Cefndon Farm,
Neath Road, Tonna,
Neath Port Talbot

Road Safety Audit - Stage 2

Barratt Homes /
David Wilson Homes

January
2017

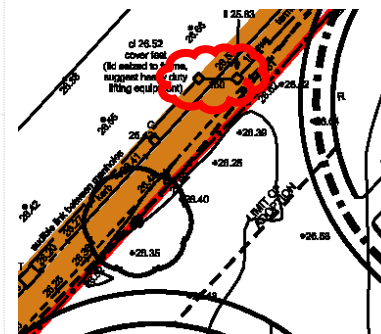
- 3.1.2 **Problem** **Manhole will become slippery when wet**
 Location **Footway along the eastern edge of the B4434 Neath Road**

The Audit Team noted from the site visit that there is a manhole cover located within the centre of the footway on the eastern side of the carriageway that will be within the carriageway when the proposed access is constructed. In the absence of any details, the Audit Team is concerned that the cover will become slippery during wet weather, and could lead to drivers (particularly riders of powered two-wheelers) losing control of their vehicles when undertaking turning manoeuvres. This could result in a vehicle hitting an oncoming vehicle or mounting the kerb and striking a pedestrian.

The Audit Team recommends that the cover is replaced or treated with appropriate anti-skid surfacing.

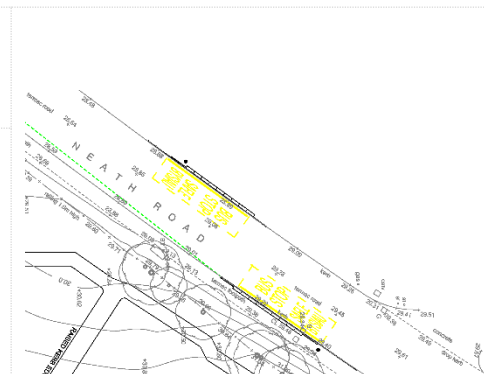
3.1.4 Problem Waiting buses will obstruct forward visibility for overtaking vehicles

Location Proposed bus stops along the B4434 Neath Road, north of the site access

The Audit Team note from the plans that it is proposed to provide northbound and southbound bus stops to the north of the site access junction, with the northbound stop approximately 30m south of the southbound stop. The Audit Team is concerned that in the event that northbound and southbound buses are waiting at the stop at the same time, the buses will obstruct forward visibility for overtaking vehicles. This could lead to vehicles attempting to pass a waiting bus into the path of an oncoming vehicle, resulting in rear-end shunt type accidents or head-on collisions.

The Audit Team recommend that the northbound bus stop is moved north of the southbound bus stop, to prevent both buses obstructing forward visibility for overtaking vehicles.

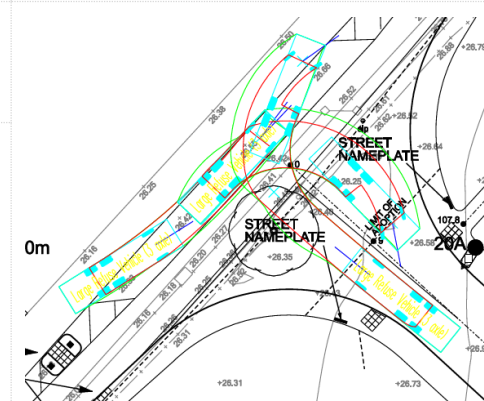
3.1.5 Problem Inadequate swept-path analysis has been provided to Audit Team

Location Proposed site access

The swept-path analysis provided to the Audit Team does not include all turning movements at the proposed site access (does not include left-in/left-out manoeuvres) and therefore the Audit Team is unable to determine whether large vehicles can access the site without conflicting with other vehicles – resulting in side swipe or rear end shunt type accidents, or pedestrians – resulting in pedestrians being hit by vehicles.

The Audit Team recommends that a full swept-path analysis is undertaken to demonstrate that the range of vehicles likely to access the site can do so safely.

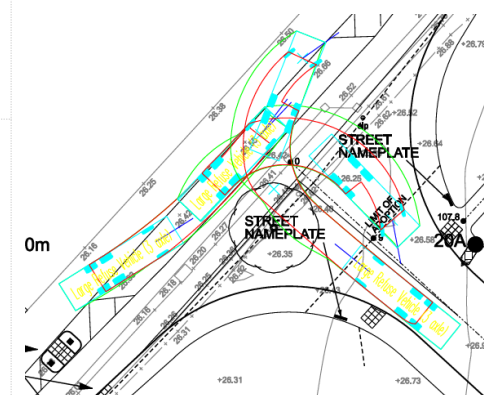
3.1.6 **Problem** **Rear of large vehicles overhang northbound running carriageway**
Location **Proposed site access**

The Audit Team note from the plans that the rear of a large refuse vehicle (turning right in to the site) over-sweeps the northbound running lane. The Audit Team is concerned that this could lead to the refuse vehicle striking a vehicle passing along the nearside edge.

The Audit Team recommends that the swept-path analysis is re-run to determine whether a large refuse vehicle can access the site without the rear of the vehicle over-sweeping the carriageway, and if necessary that the ghost-island right turn lane is widened to avoid potential conflicts.

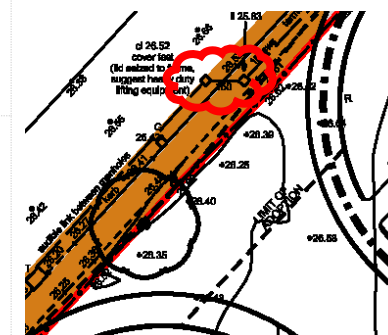
3.1.7 **Problem** **Manhole covers may become slippery when wet**
Location **Within bell-mouth of proposed site access**

The Audit Team note from the Section 278 Agreement Plan (1605/237) that there are a number of manhole covers shown within the junction bell-mouth of the proposed site access. The Audit Team is concerned that during wet weather the covers will become slippery, and could lead to drivers (particularly riders of powered two-wheelers) losing control of their vehicles when undertaking turning manoeuvres. This could result in a vehicle hitting an oncoming vehicle or mounting the kerb and striking a pedestrian.

The Audit Team recommends that the cover is replaced or treated with appropriate anti-skid surfacing.

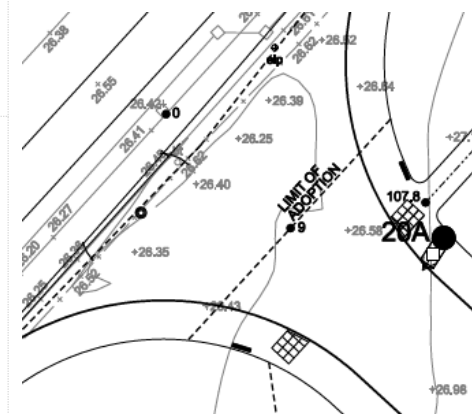
3.2.1 Problem Pedestrian crossing situated at the end of the pedestrian ramp

Location	Adjacent to the proposed site access
-----------------	---

The Audit Team note from the Engineering Layout (1605/201M) that the tactile paving has been relocated further in to the site, at the end of the pedestrian ramp parallel to the B4434. The audit team is concerned that this could increase the potential for pedestrians (and in particular toddlers) entering the carriageway injudiciously into the path of an oncoming vehicle resulting in pedestrians being hit by a vehicle.

The Audit Team recommends that the pedestrian ramp includes a 'dog-leg', level with the footway, so that the ramp does not lead directly to the tactile paving.

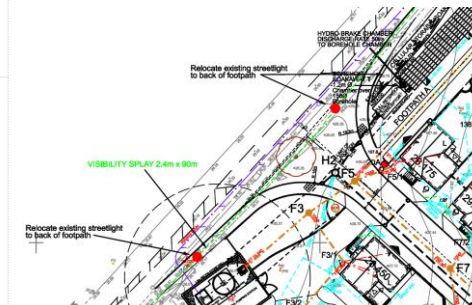
3.2.2 Problem Pedestrians obscured from view as a result of shadowing

Location	Proposed site access junction
----------	-------------------------------

The Audit Team note from the plans that it is proposed to relocate the existing lighting columns to accommodate the site access junction. The Audit Team is concerned that relocating the lighting columns will affect the lighting levels throughout the junction, resulting in shadowing, and could obscure from view pedestrians waiting to cross the road. This could lead to pedestrians being hit by oncoming vehicles.

The Audit Team recommends that the lighting levels through the junction are reviewed, and that the appropriate lighting is provided throughout the junction.

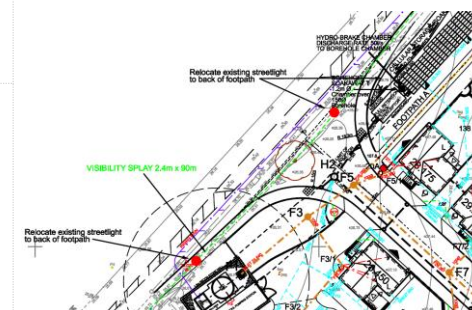
3.3.1 **Problem** Pedestrians obscured from view because of shadowing

Location Proposed site access junction

The Audit Team note from the plans that it is proposed to relocate the existing lighting columns to accommodate the site access junction. The Audit Team is concerned that relocating the lighting columns will affect the lighting levels throughout the junction, could lead to shadowing, and could obscure from view pedestrians crossing the side road of the junction.

The Audit Team recommends that the lighting levels through the junction are reviewed, and that the appropriate lighting is provided.

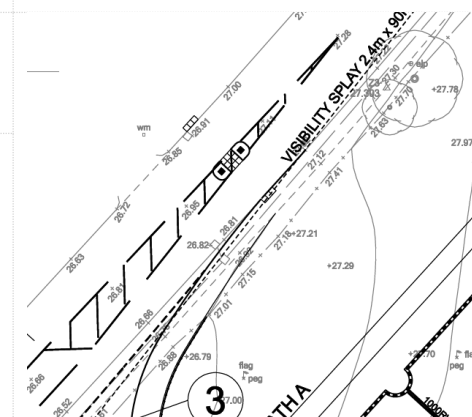
3.3.2 **Problem** Inadequate length of hatched taper

Location Pedestrian refuge north of the proposed site access

The Audit Team note from the plans that the length of hatched taper located at the pedestrian refuge, north of the site access, is inadequate. The Audit Team is concerned that a short taper length may not provide enough warning to oncoming vehicles that the carriageway width is narrowing. This could lead to vehicle conflict with the pedestrian refuge.

The Audit team recommends that the length of the hatched taper be increased to provide sufficient indication to drivers of carriageway narrowing.

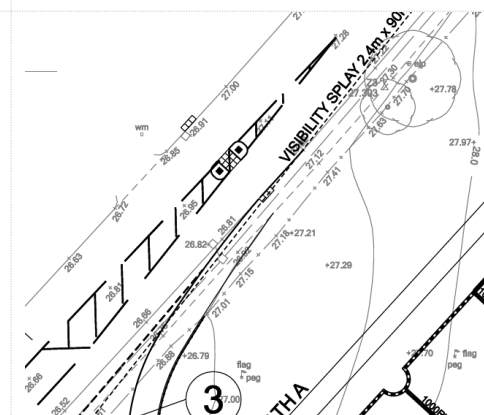
3.3.3 **Problem** Hatched taper markings direct vehicle towards pedestrian refuge

Location Pedestrian refuge north of the proposed site access

The Audit Team note from the plans that the hatched taper markings do not run to the edge of the pedestrian refuge, leaving an element of the pedestrian refuge exposed to oncoming vehicles. The Audit Team is concerned that the positioning of the taper markings may be misleading to passing vehicles, encouraging them to drive within proximity, and potentially coming into contact with the pedestrian refuge.

The Audit team recommends that the alignment of the taper markings be adjusted, to prevent oncoming vehicles from coming into contact with the pedestrian refuge.
